| Model: Stinger – P3/P4 | | | Date | e: 30-Apr-99 | 9 | No.: MG031001 |
| Modified Article: I | Power Supply Cord | | | Prepared | by: K. | Ugaeri |
| From: Technical Se | rvice Dept., GTS Division | | | | | |

3. BY-PASS FEED UNIT (G031)

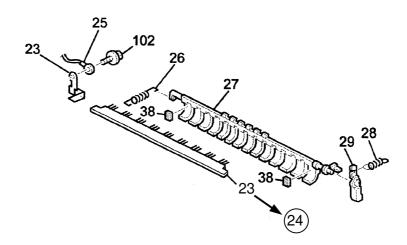
Please correct the illustration index in your parts catalog as follows:

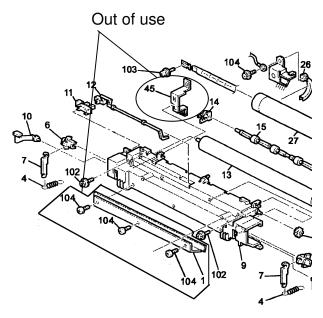
The toner on the developed paper may be attracted to the fusing entrance guide, causing the toner to fall onto the printer paper. To prevent this, the fusing entrance guide and grounding plate are no longer used.

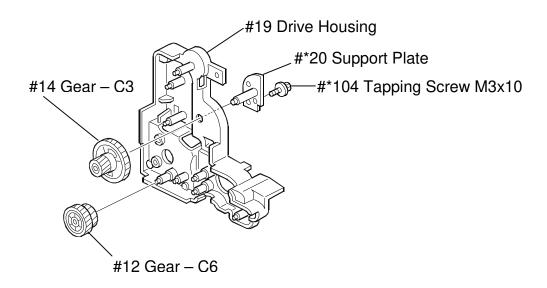
To minimize jitter in the image, the Gear – C3 has been modified. Refer to MB: MG031009 issued on February 29, 2000. In addition, the following parts have also been modified as follows:

As with the Gear – C3, the hollow areas in this drive gear have been eliminated from the design, and the gear is now perfectly solid. As a result, the weight and therefore inertia of the gear has been increased.

The old shaft for the Gear- C3 was previously mounted on the old drive housing, and it was made of plastic. To minimize the play between the Gear - C3 and its shaft, the material of the shaft has been changed to metal. The old drive housing (G0291100) has been divided into a housing (G0291121) and support plate (G0291122).

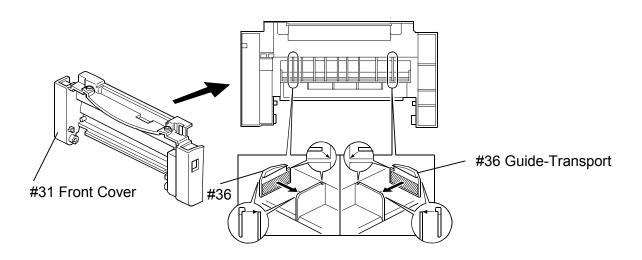
| Part Number | Description | Index | Qty |
|-------------|--|-------|-----|
| G0301258 | Guide – Transport | *36 | 2 |

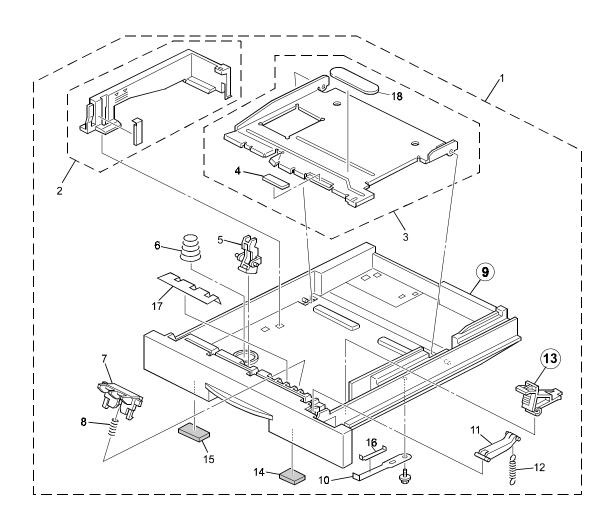
The Stopper Base Plate has been changed to increase the durability of the fulcrum against unforeseen stresses. To facilitate this, the shape of the attachment opening in the Paper Cassette has also been changed.

Note: When replacing either one of these old parts with its new version, it is necessary to replace both together as a set.

(G031/G049)

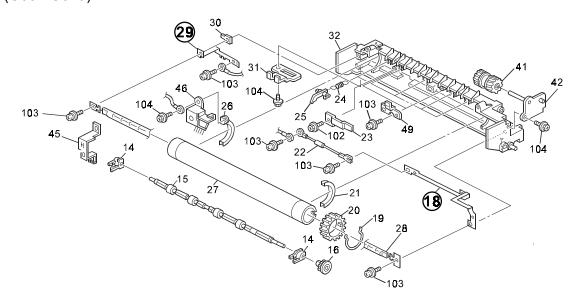
| Old part number | New part number | Description | Q'ty | Int | Page | Index | Note |
|--------------------|-----------------|-----------------|------|-----|------|-------|------|
| G0304241 | G0304243 | Grounding Plate | 1 | 0/0 | 11 | 24 | |

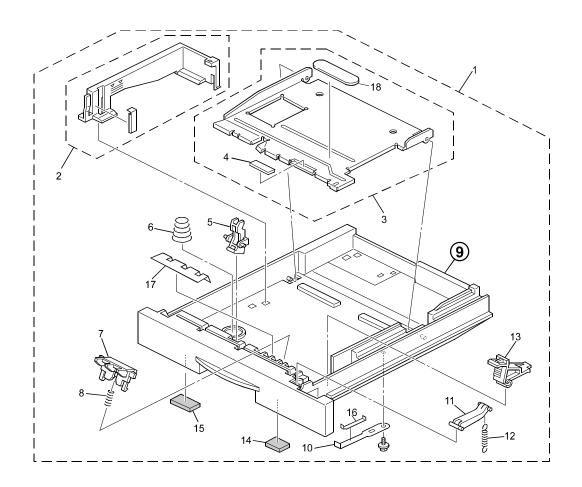
| Old part number | New part number | Description | Q'ty | Int | Page | Index | Note |
|--------------------|-----------------|----------------|------|-----|------|-------|------|
| G0302701 | G0302703 | Paper Cassette | 1 | 0/0 | 5 | 9 | |
